#### **INSTRUCTIONAL BULLETIN NO. 13-20**

#### **Regarding Revised Standard Drawings**

**Effective for the February 2014 Letting (December 4 turn-in)**, the following Standard Drawings are revised and Section V of the Design Guidelines is revised for this update.

PARALLEL CURB RAMP

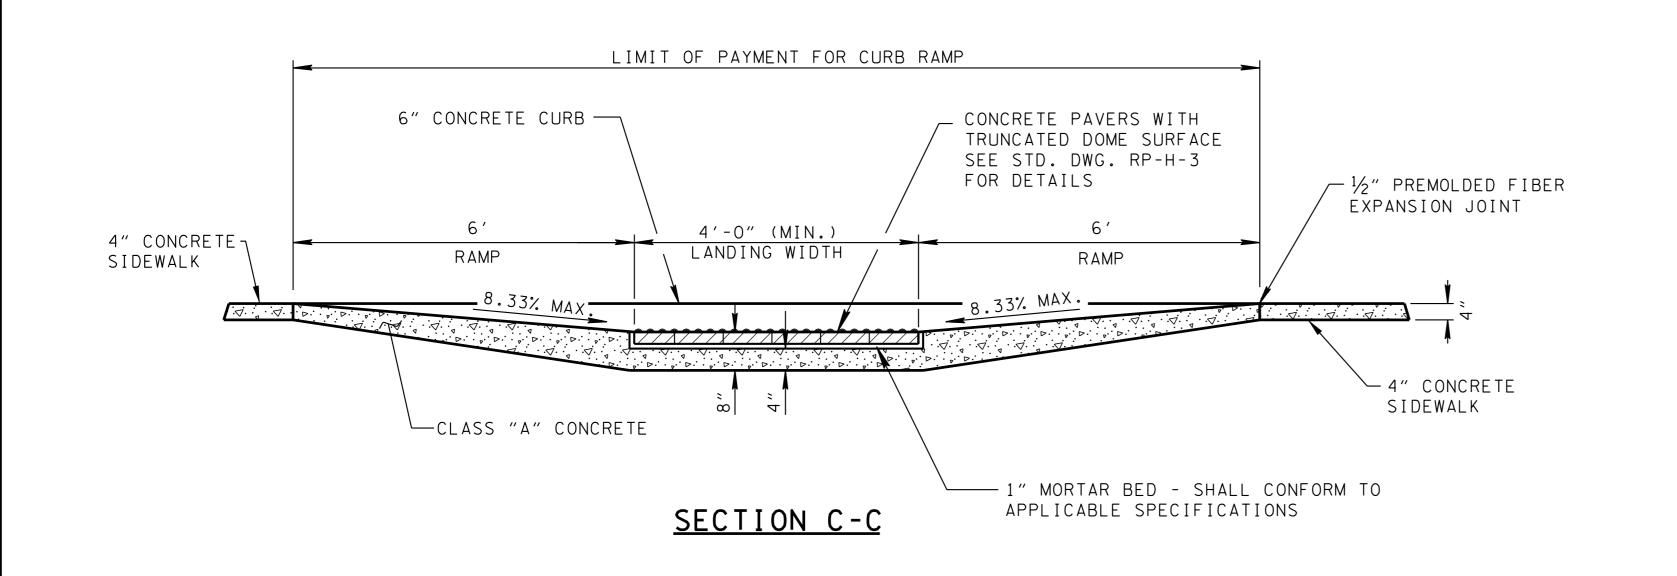
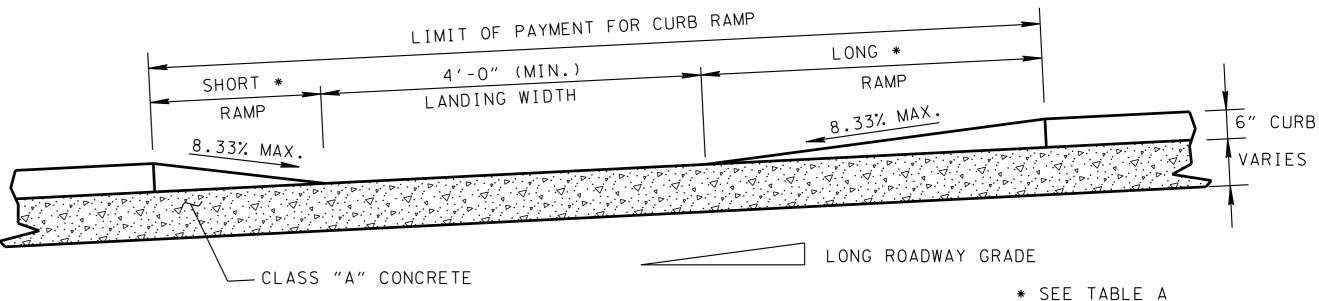
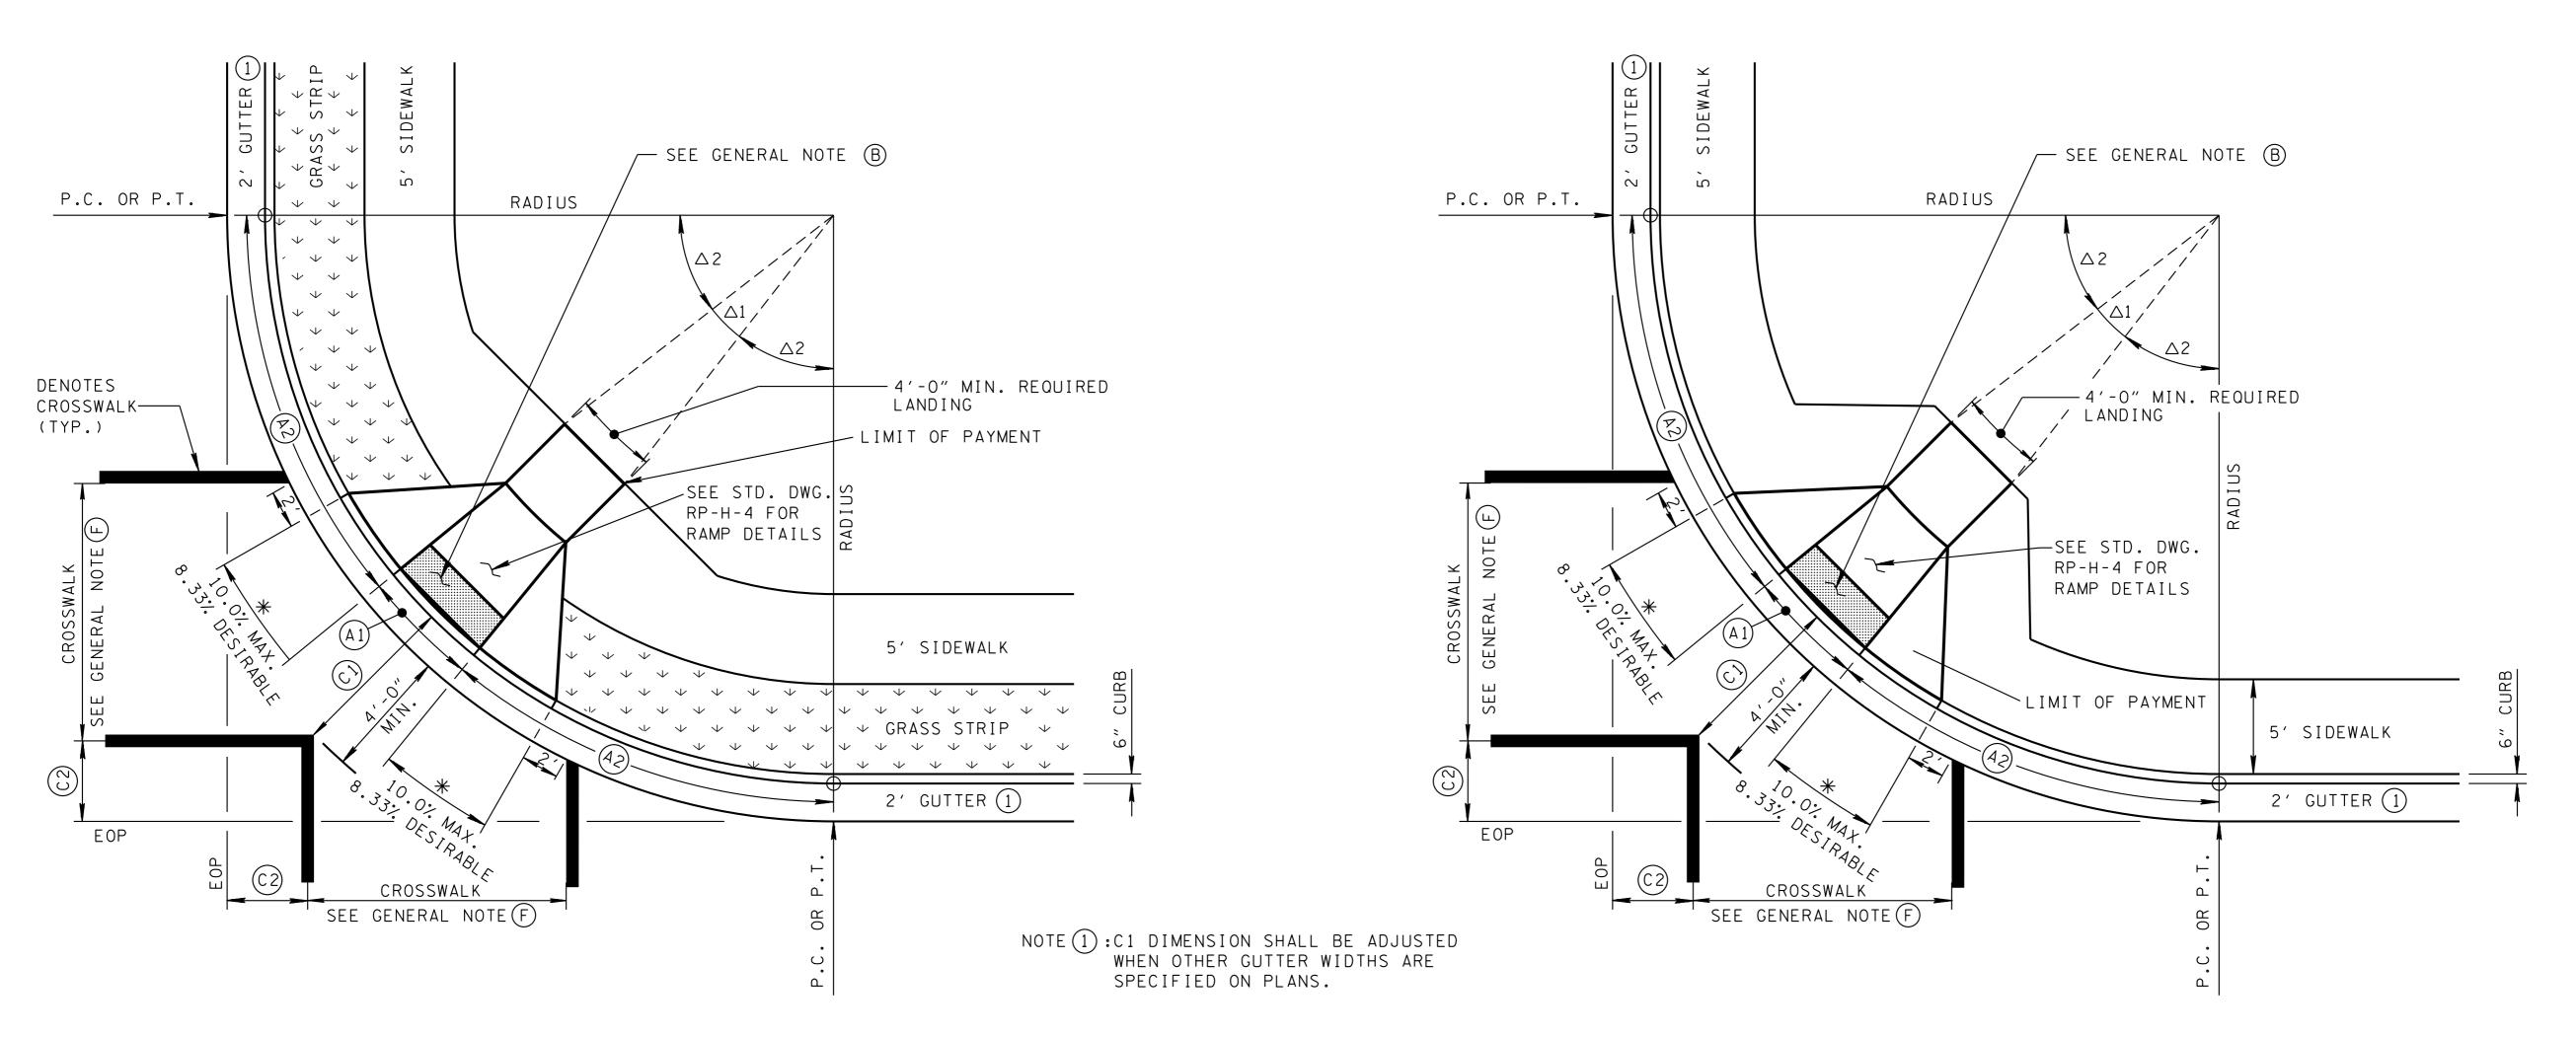
☐ REV. 6-4-13: CHANGED CROSS SLOPE TO 1.5 % DESIRABLE. ADDED NOTES (G) AND (H). CHANGED ITEM DESCRIPTION.

- (E) IF PEDESTRIAN SIGNAL IS PROPOSED SEE TOOT TRAFFIC DESIGN MANUAL FOR PLACEMENT.
- (F) IF MAILBOXES ARE REMOVED DURING INSTALLATION OF THE RAMP PROVIDE A 12" X 12" OPENING BEHIND THE CURB (SEE RP-S-7).
- G DESIRABLE CROSS SLPOE IS 1.5%, ABSOLUTE MAXIMUM IS 2%.
- (H) SEE NOTES (I) AND (O) ON RP-H-3.

> PERPENDICULAR CURB RAMP TYPE 1

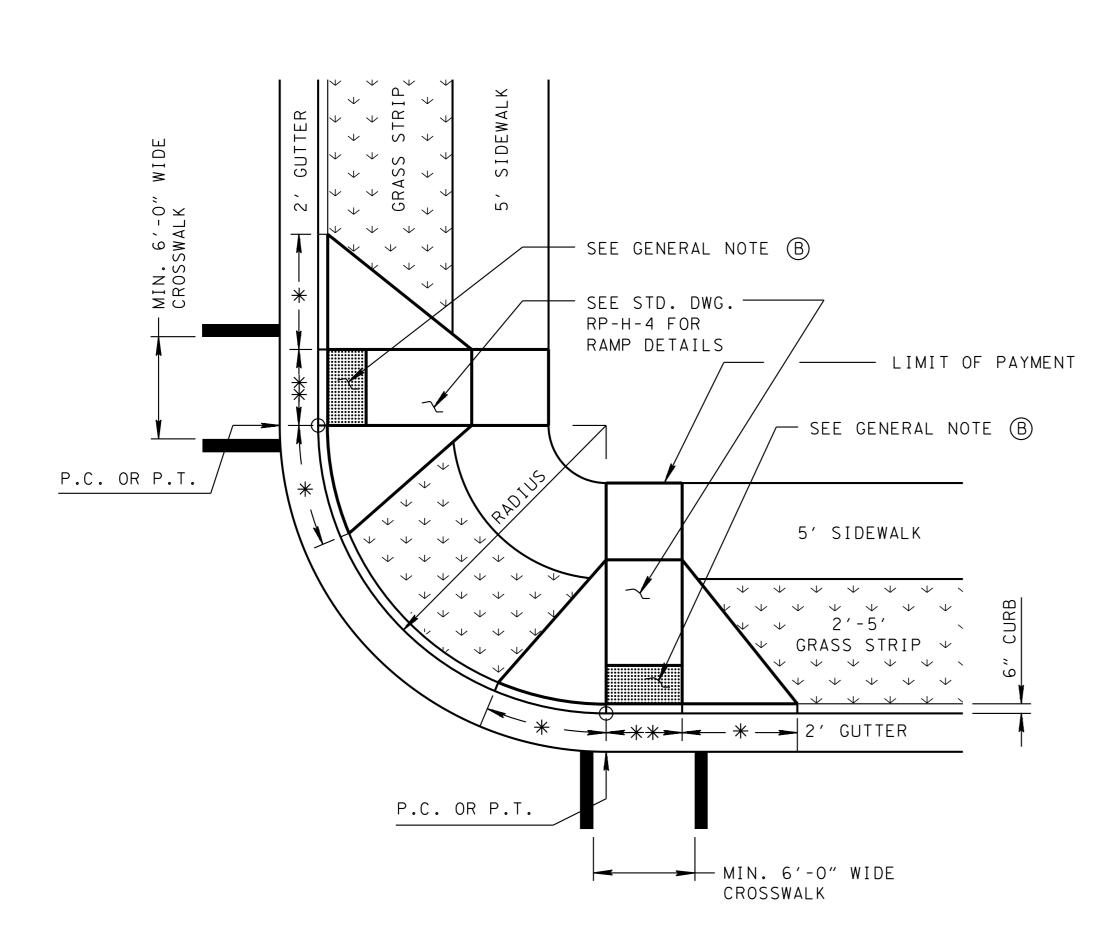
☐ REV. 6-4-13: REVISED NOTE ©, CHANGED TITLE.

> DETAILS FOR STANDARD CONCRETE SIDEWALKS

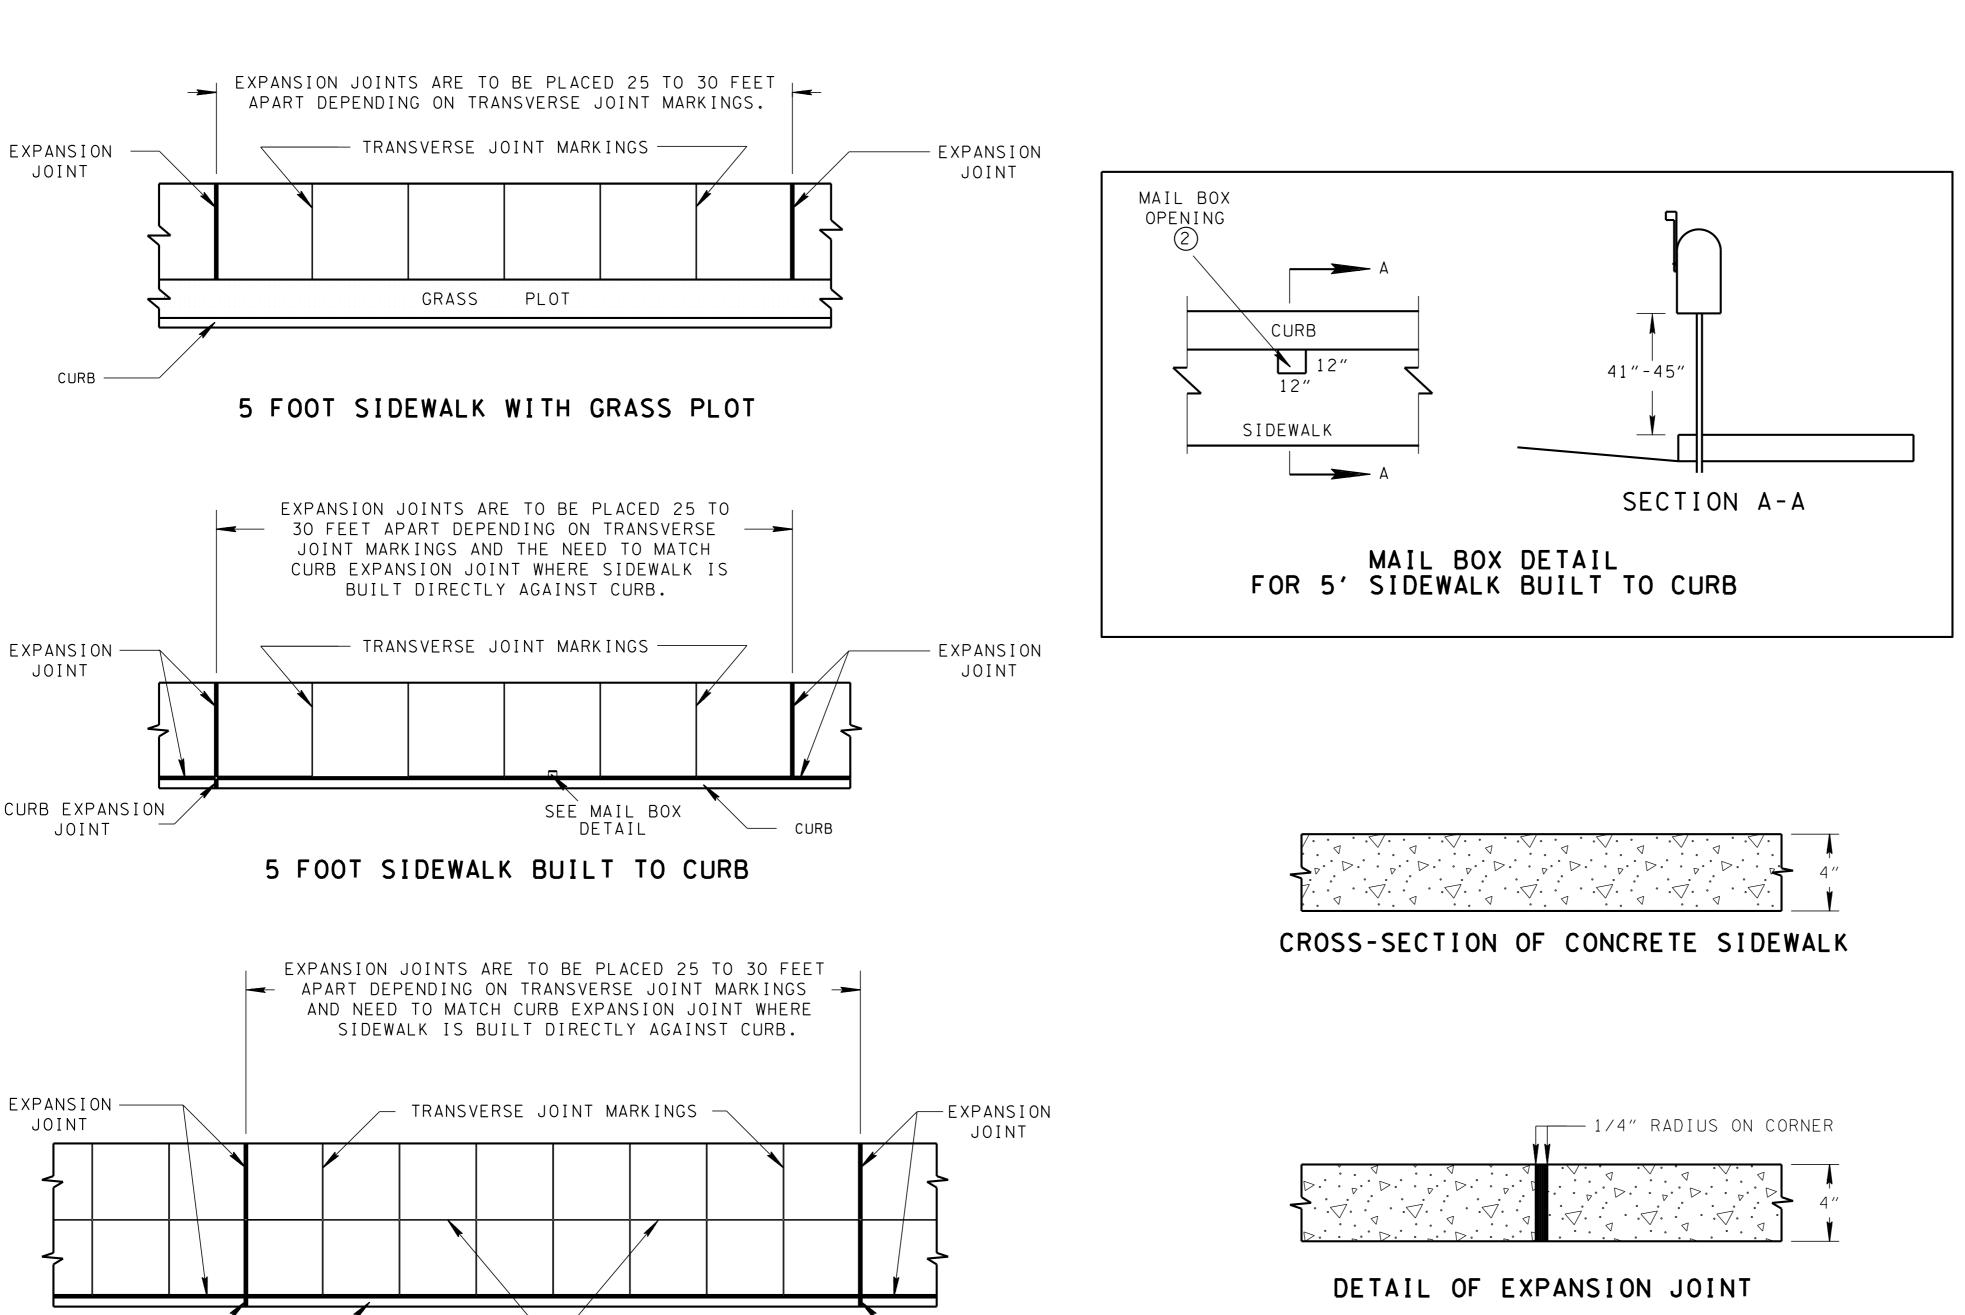
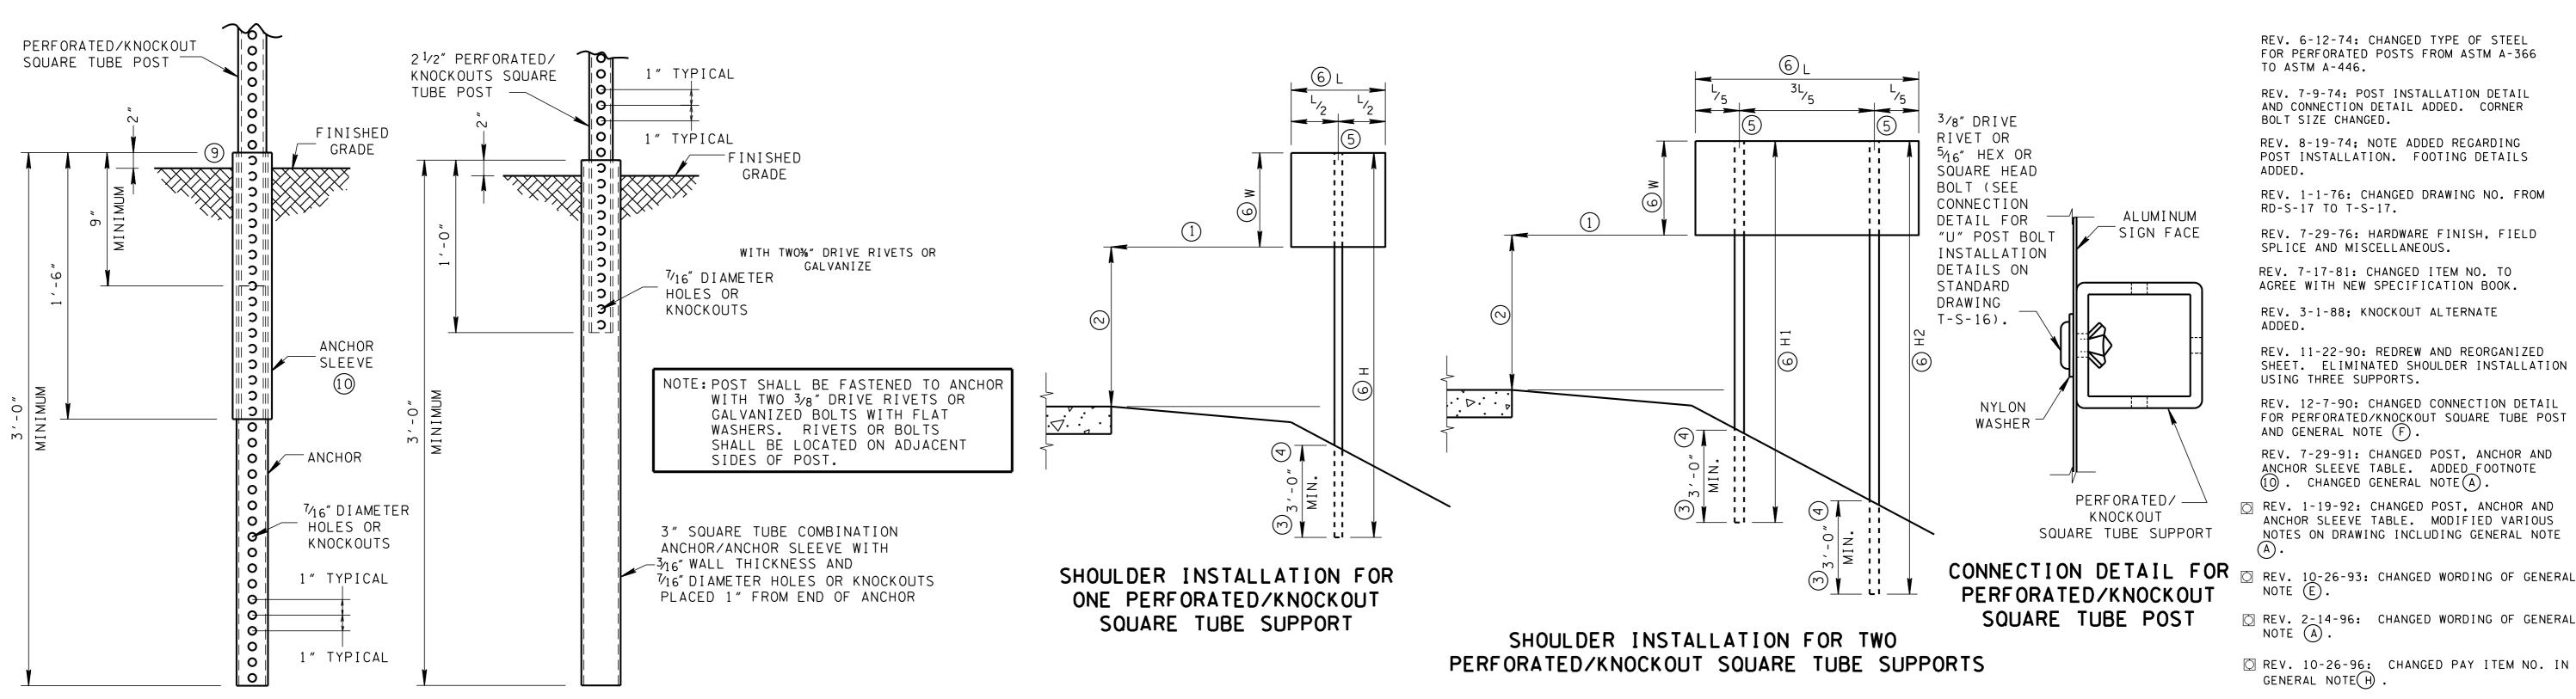
REV. 6-4-13: REVISED NOTES

(C) AND (G) AND ADDED NOTE (L).

- TRANSVERSE JOINT MARKINGS ARE TO BE MADE TO FORM BLOCKS AS NEARLY TO SQUARE AS PRACTICAL.
- DESIRABLE SIDEWALK CROSS SLOPE IS 1.5 %, ABSOLUTE MAXIMUM IS 2.0 %.

STANDARD GROUND MOUNTED SIGN USING PERFORATED/ KNOCKOUT SQUARE

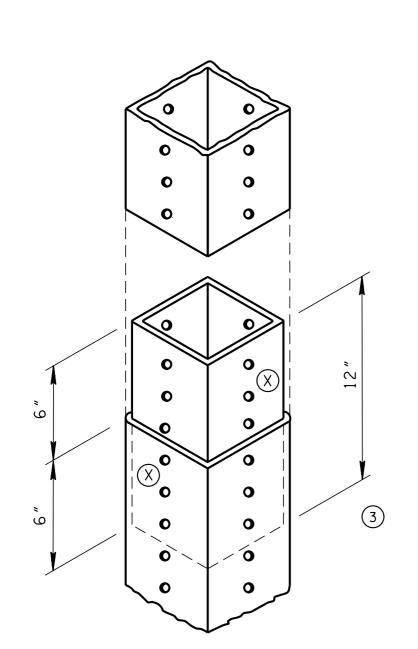
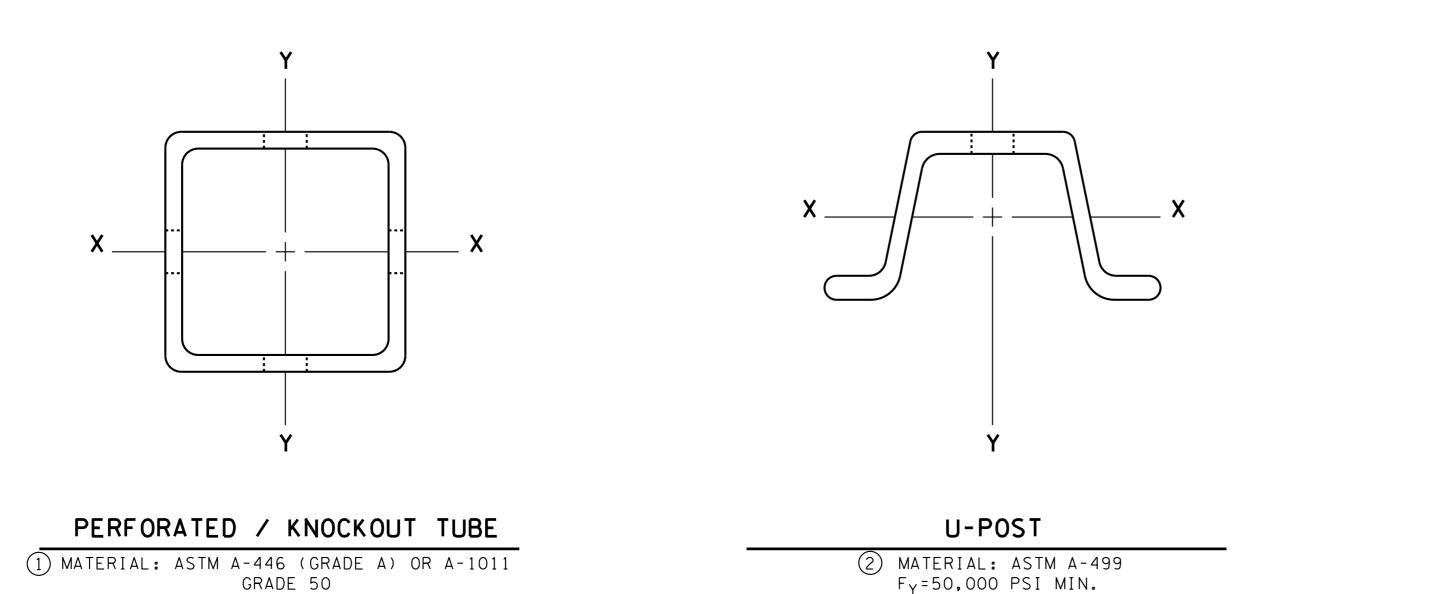
- REV. 1-19-92: CHANGED POST, ANCHOR AND ANCHOR SLEEVE TABLE. MODIFIED VARIOUS NOTES ON DRAWING INCLUDING GENERAL NOTE
- REV. 2-14-96: CHANGED WORDING OF GENERAL NOTE A.
- REV. 10-26-96: CHANGED PAY ITEM NO. IN GENERAL NOTE(H) .
- $\bigcirc$  REV. 7-19-13: REMOVED 2½", 10 AND 12 GAUGE POST FY FOR 12GAUGE CHANGED TO 60 KSI. REMOVED TYPE 4 FOOTING.

- (A) PERFORATED/KNOCKOUT POSTS SHALL BE SQUARE TUBE FORMED FROM USS GAGE (12 GAGE) ASTM A-446 COLD ROLLED CARBON STEEL OR A-1011 HOT ROLLED CARBON SHEET STEEL. THE MINIMUM YIELD (Fy) IS TO BE 60,000 POUNDS PER SQUARE INCH, OR USS 14 GAGE HAVING A MINIMUM YIELD STRENGTH OF 60,000 POUNDS PER INCH. THE SQUARE TUBES SHALL BE WELDED DIRECTLY IN THE CORNERS BY HIGH FREQUENCY RESISTANCE WELDING OR EQUAL. THE SUPPORT POSTS ARE TO BE EXTERNALLY SCARFED TO AGREE WITH STANDARD CORNER RADII OF 32" + 1/64".
